# SERVICE BULLETIN

KWM-380 TRANSCEIVER (622-5093-001)  
HF-380 TRANSCEIVER (622-3580-001)  
RECEIVER-EXCITER ASSEMBLY A3 (638-6908-002)

## SERVICE BULLETIN NO 14

### TRANSMIT AUDIO FREQUENCY RESPONSE AND MIC CARRIER CONTROL NOISE

P/O Receiver-Exciter Assembly A3  
Figure 1

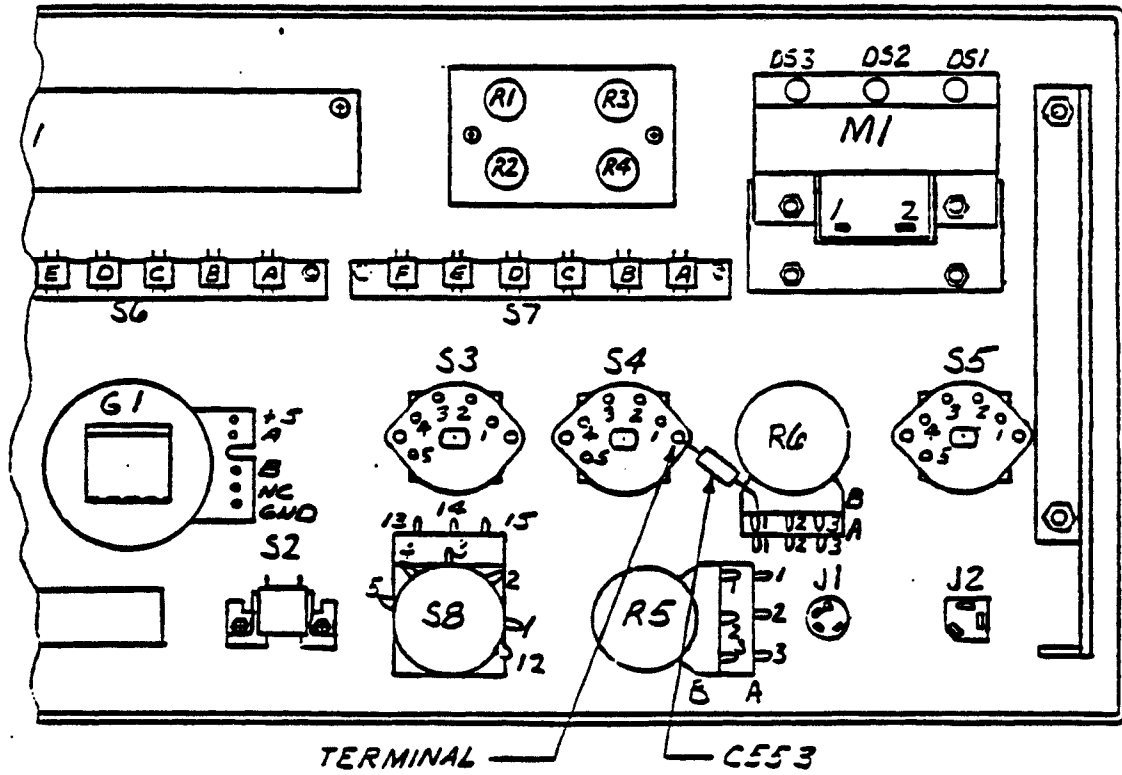
**NOTE:** Refer to figure 1 for location of C500 and C509.

- D. Remove 470-pF capacitor C500 and replace it with a 2200-pF capacitor (913-5019-120).
- E. Remove 1- $\mu$ F capacitor C509 and replace it with a 4.7- $\mu$ F capacitor (184-9102-390).

P/O Front Panel Assembly A10  
Figure 2

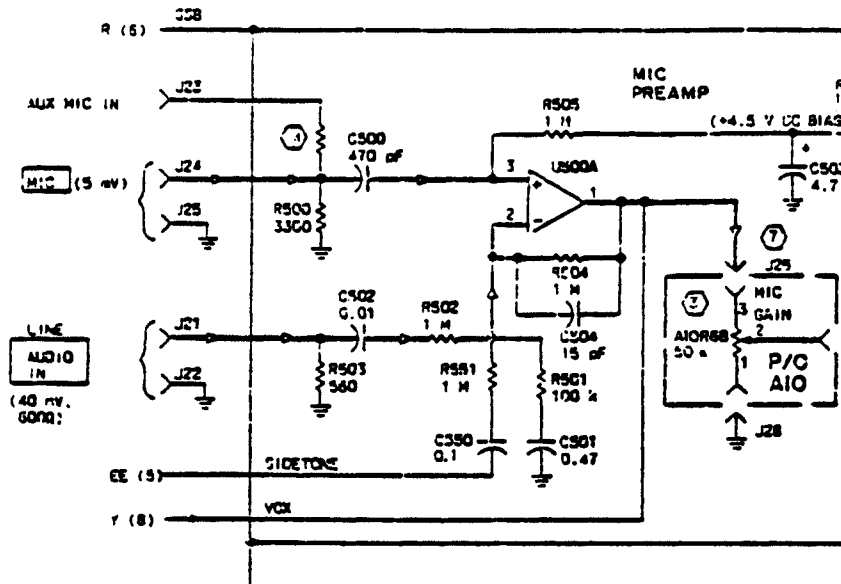
**NOTE:** Refer to figure 2 while performing steps F through H. Capacitor C553 is part of receiver-exciter assembly A3 but is mounted on front panel assembly A10. If C553 were mounted on the A3 card, a circuit trace cut on the bottom of the card would be required making it necessary to remove the card from the radio. Refer to figure 3 for a schematic diagram which shows the location of C553.

- F. Install an insulated terminal (306-1018-000) on the S4 mounting screw nearest potentiometer R6. If not enough threads are available, remove the nut.
- G. At R6B-1, remove the white wire and reconnect it to the new terminal installed in step F.

- H. Install 0.1- $\mu$ F capacitor C553 (913-3331-030) from the new terminal to R6B-1.
- I. Solder and check all new connections.
- J. Perform the following passband tuning oscillator alignment:

P/O Receiver-Exciter Assembly A3,  
Schematic Diagram  
Figure 3

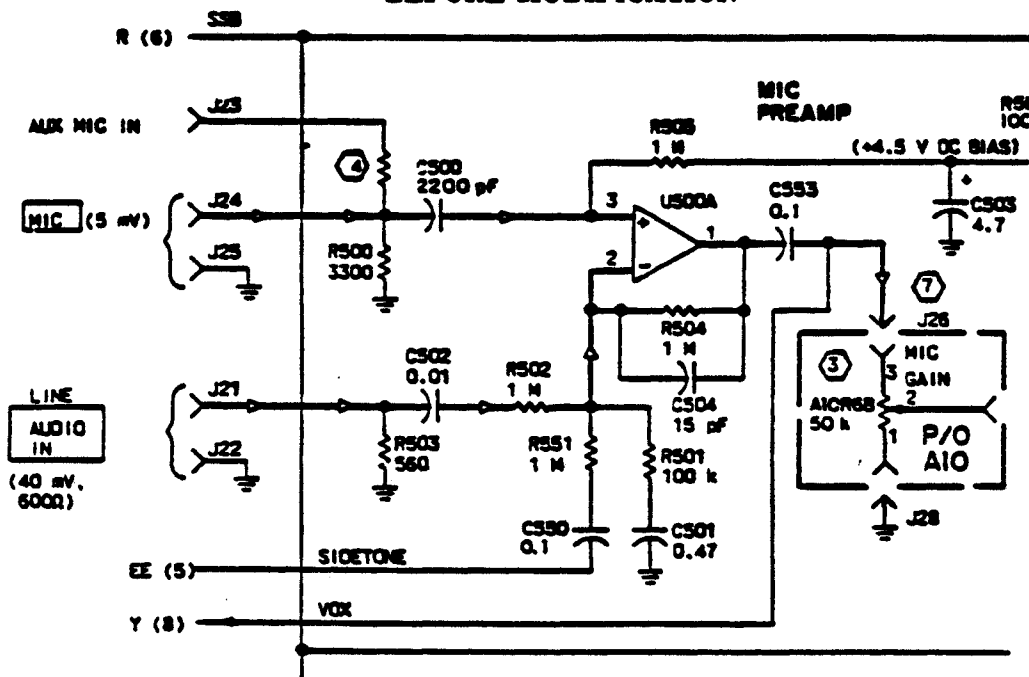
When the mic carrier control is rotated, it may produce noise in the transmit audio output. This modification adds a dc blocking capacitor in series with the top of the mic carrier control potentiometer to prevent noise generation.
